Forsyth County Procurement

ADDENDUM #6

RFP 20-78-1620

For: Providing all labor, equipment and materials for the construction of a new Juvenile Justice Center at 875 Lanier 400 Parkway, Cumming, GA 30040. Project includes a multi-phased site development, demolition of existing motel structures and construction of new 62,000 square foot Juvenile Court building.

3 PUBLIC ELEVATORS EL- C&D - INTERIOR ELEVATIONS

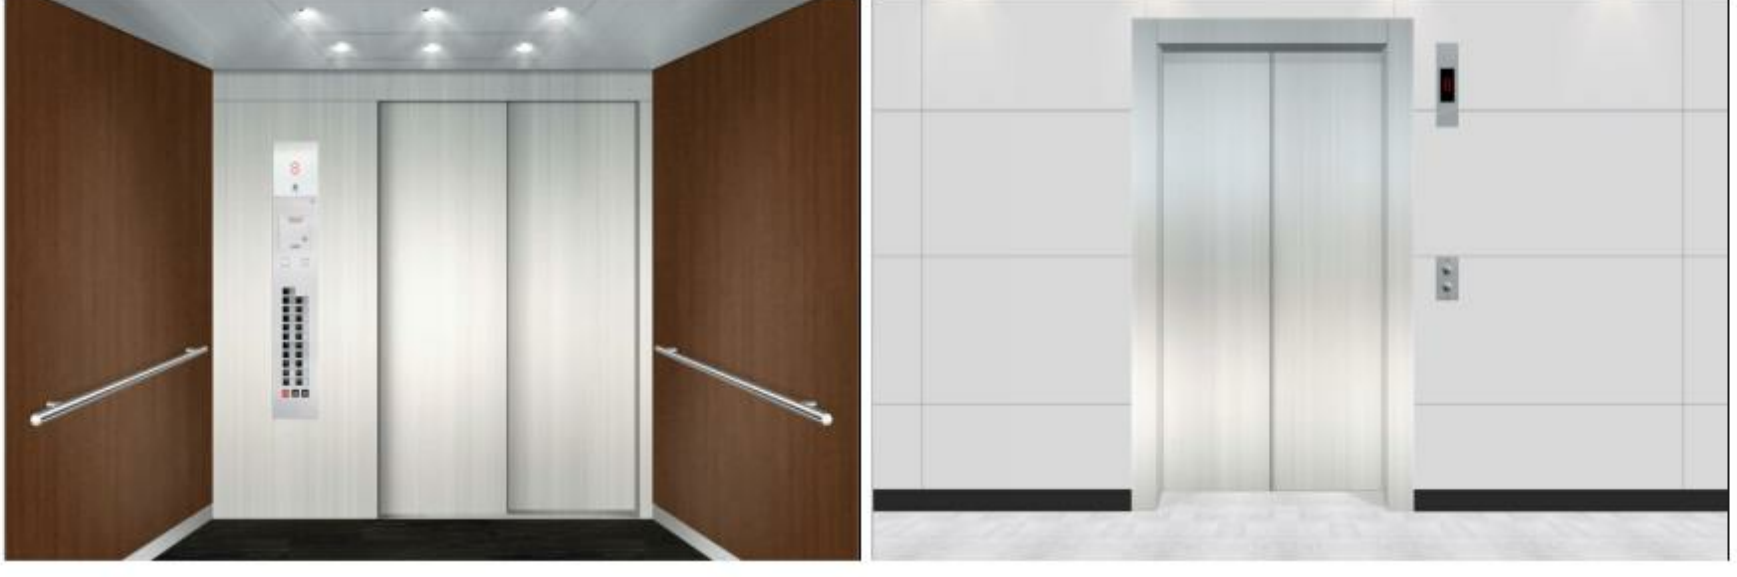
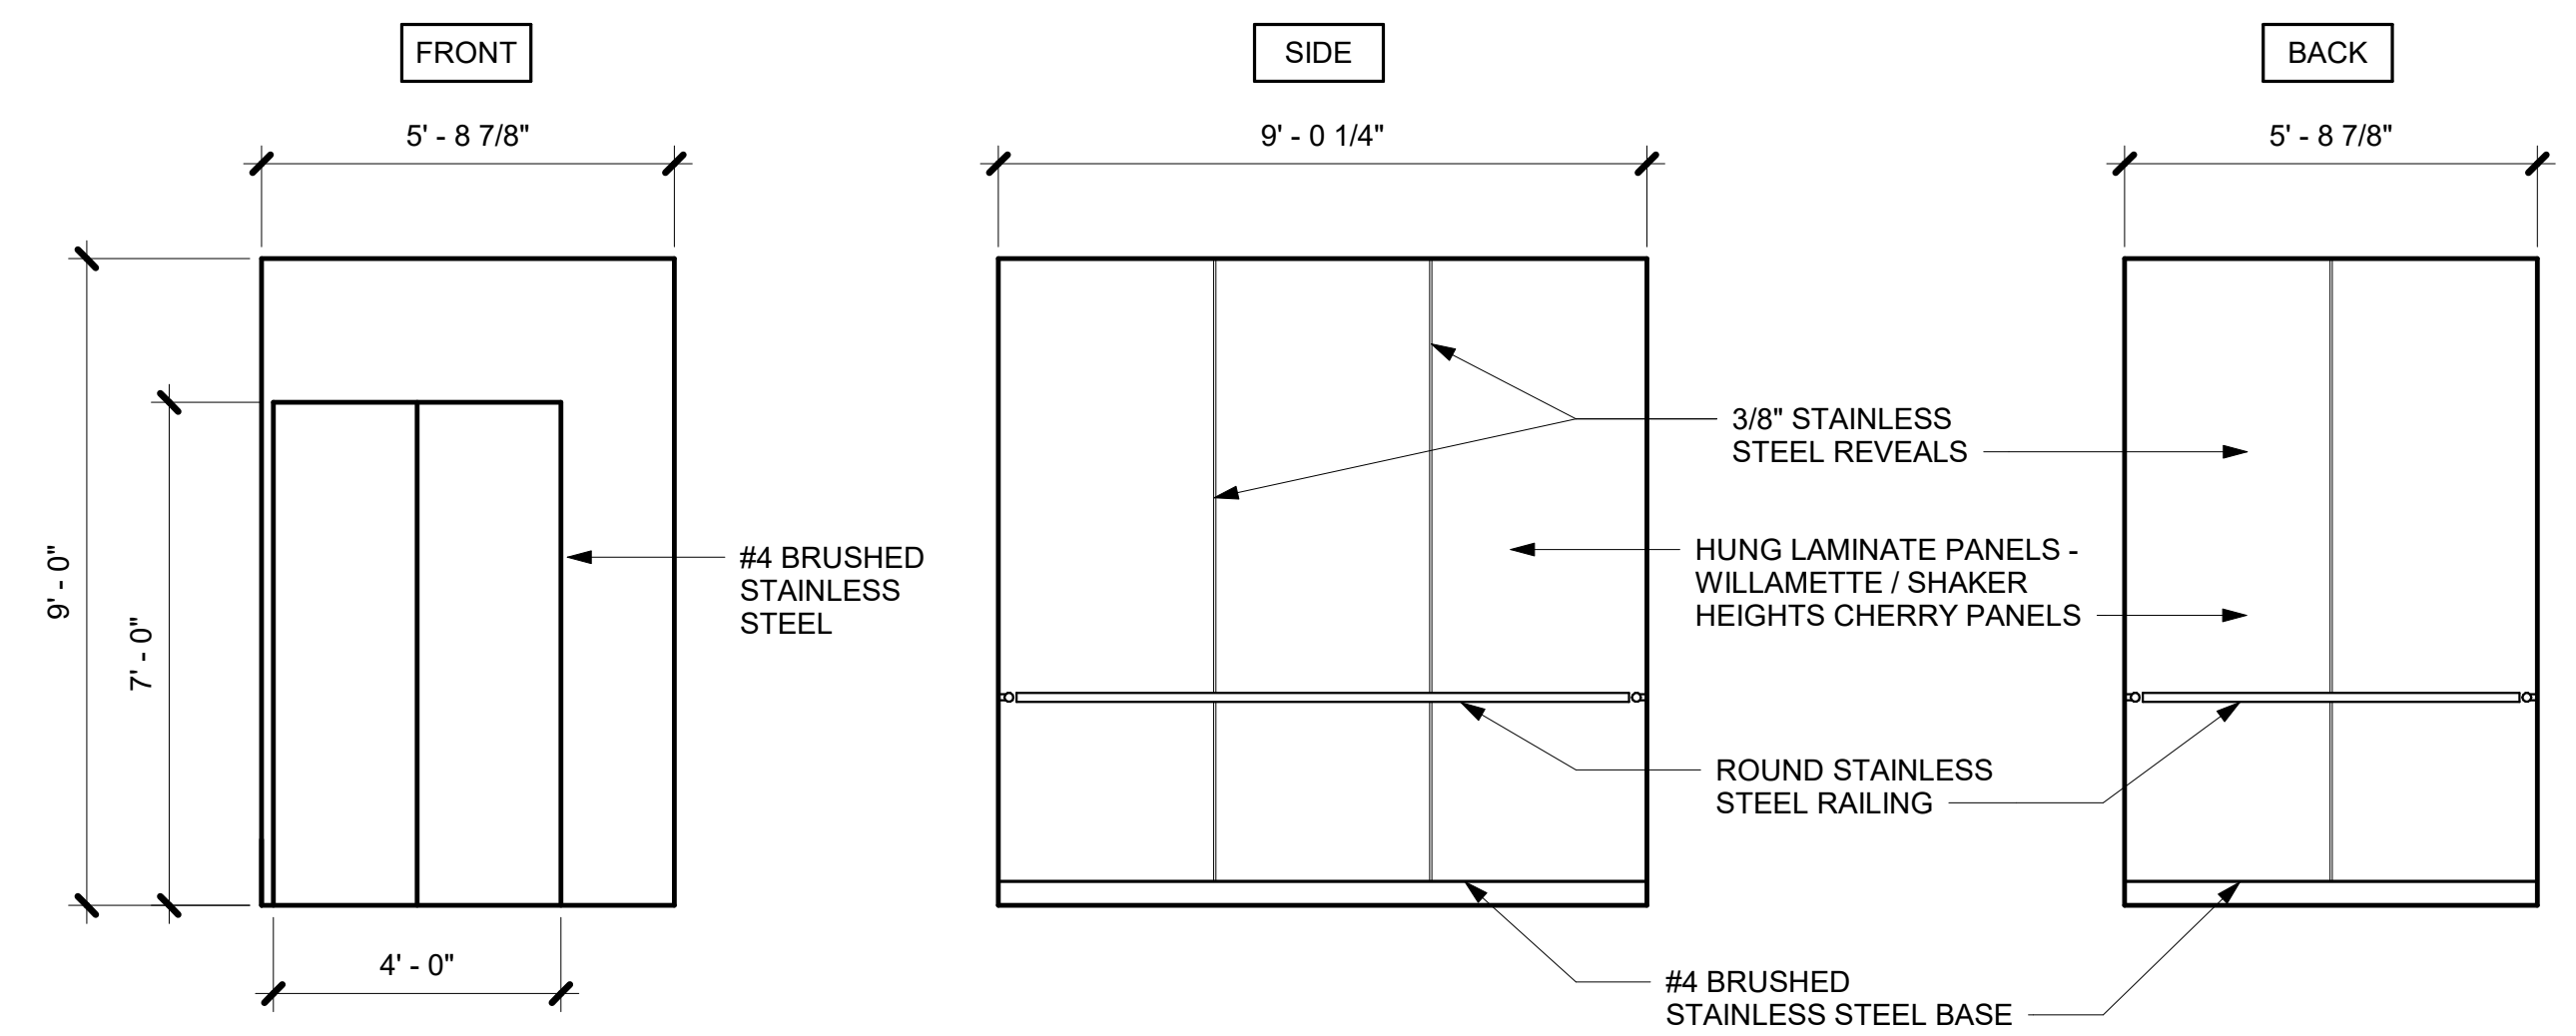
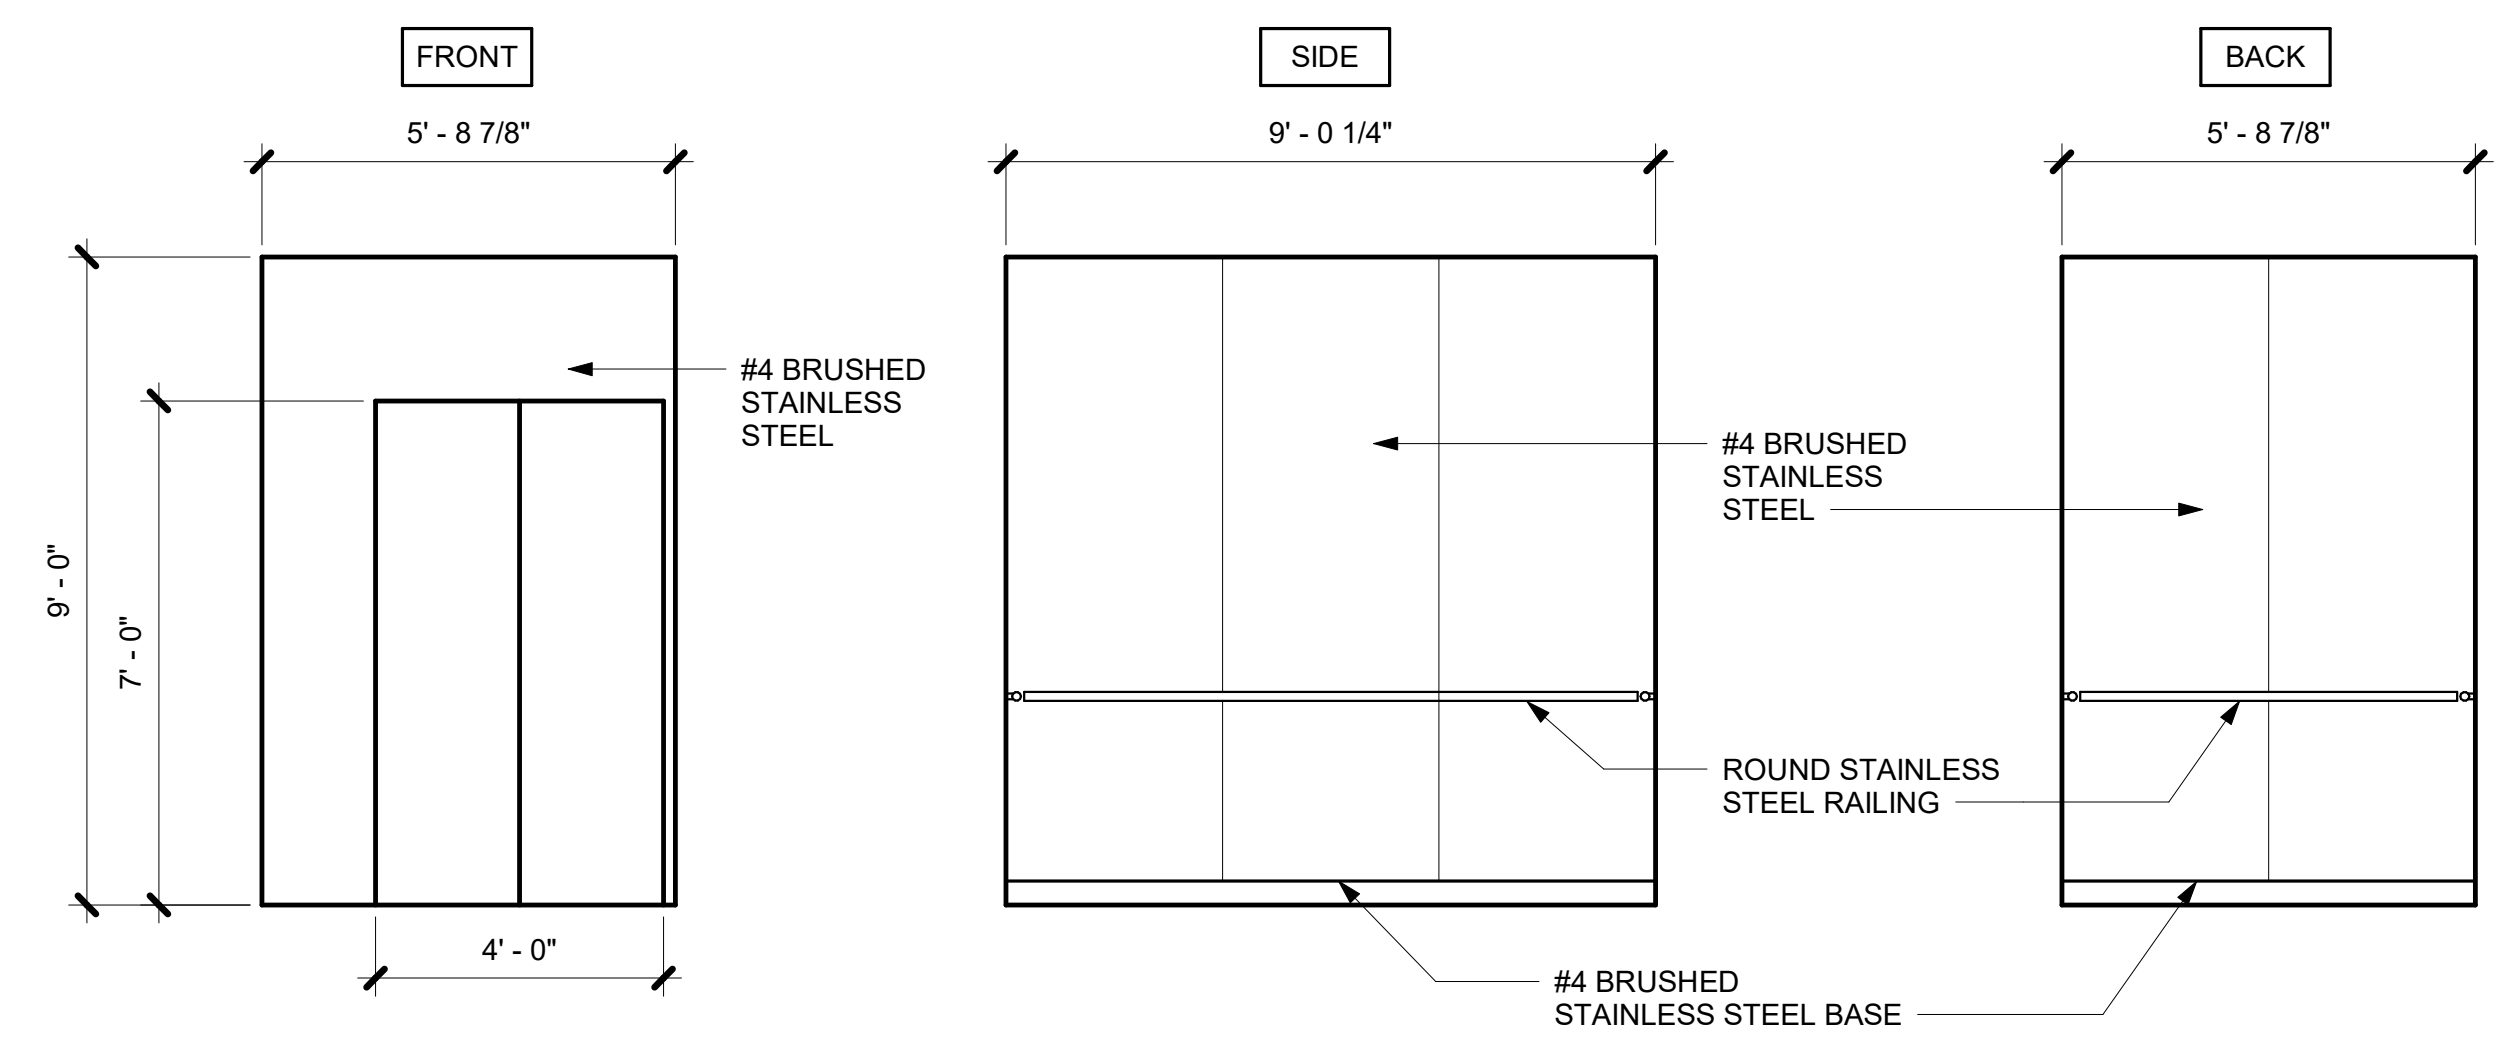
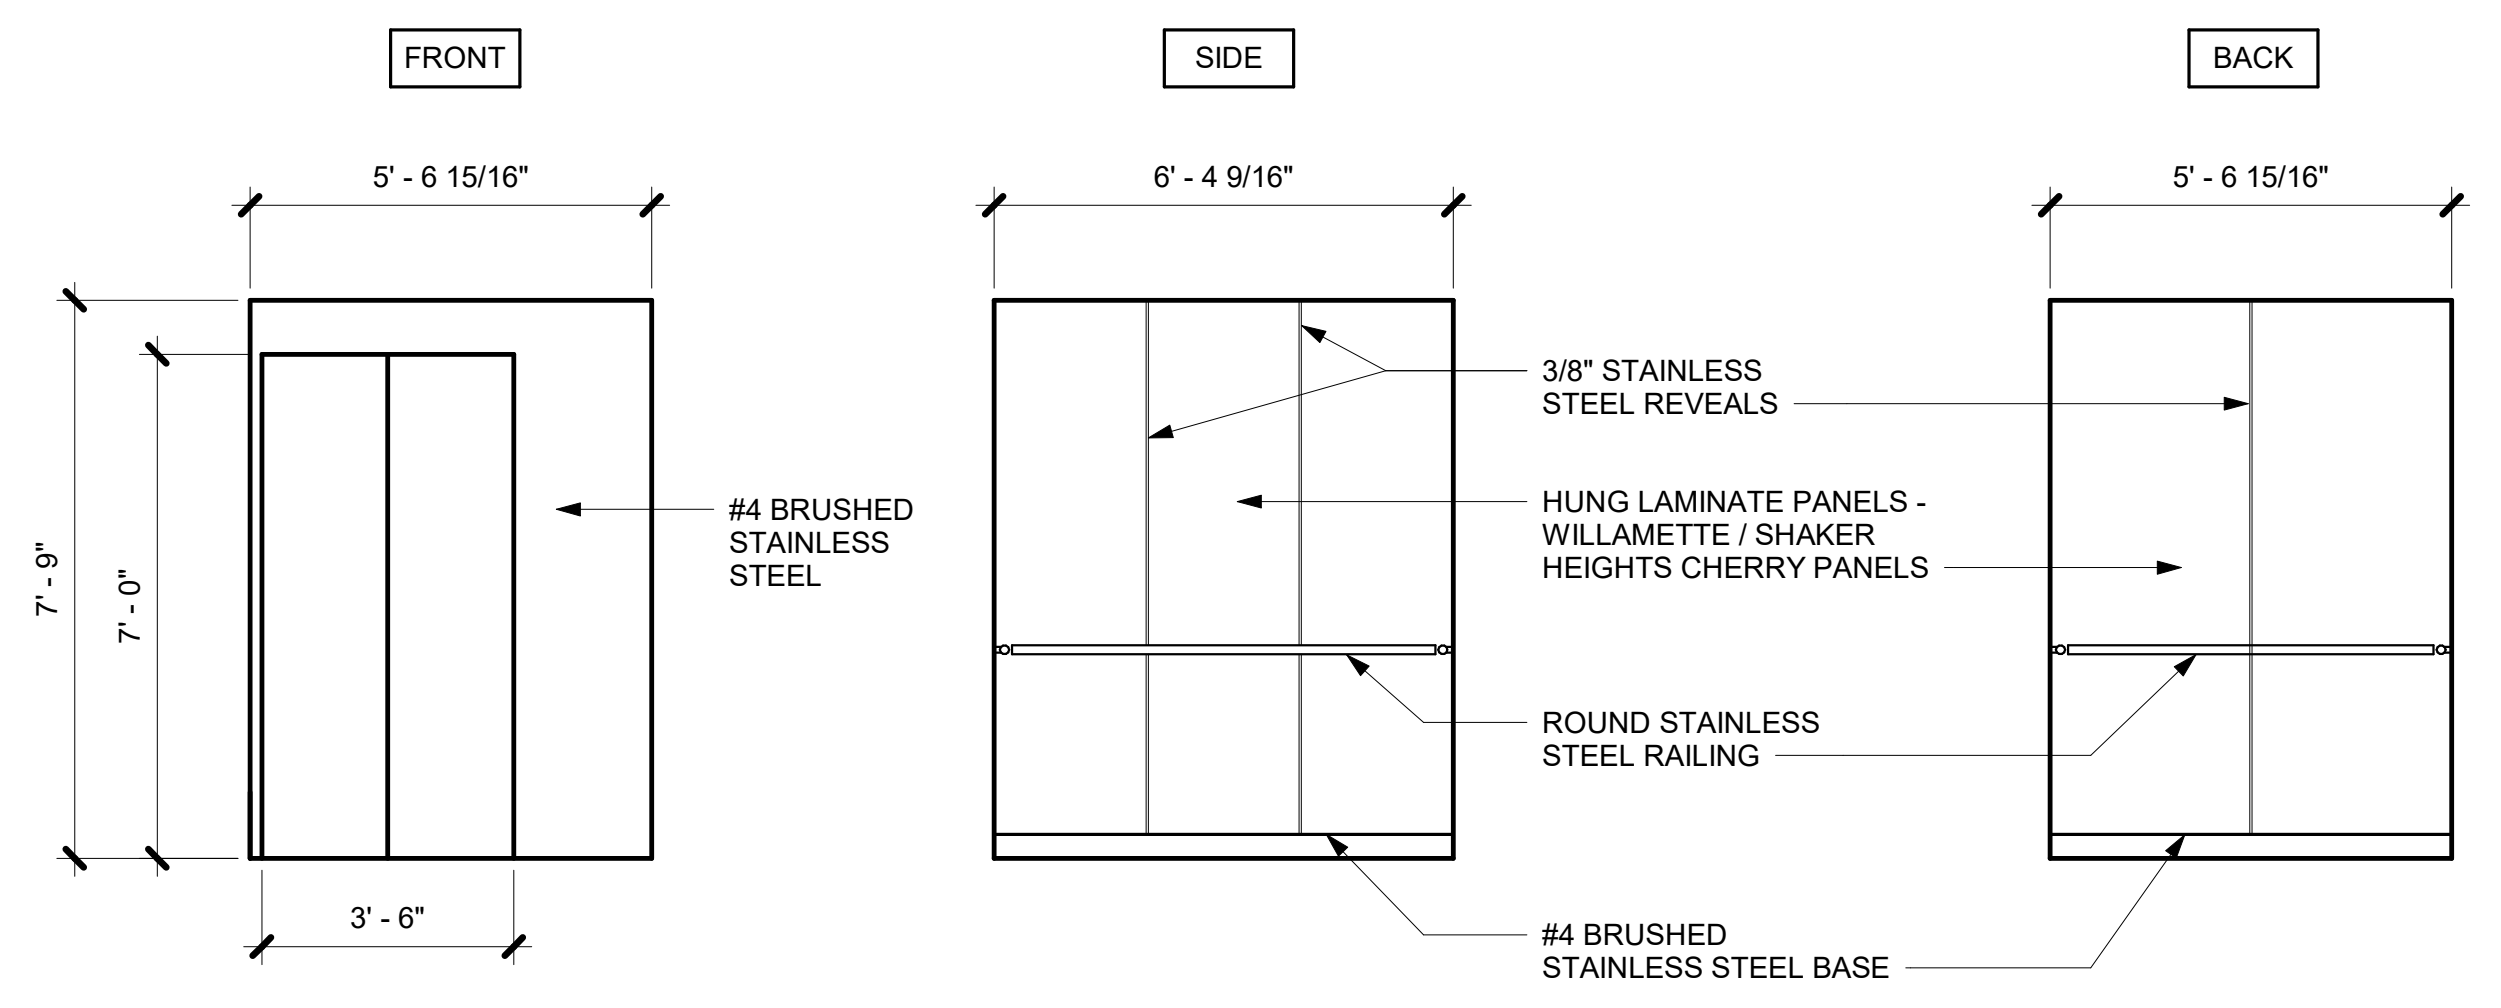
3. Interior elevators and finishes added.
4. Reference sheet ID-4.02 ELEVATORS – INTERIOR ELEVATIONS released under addendum #06 dated 07/16/2020.
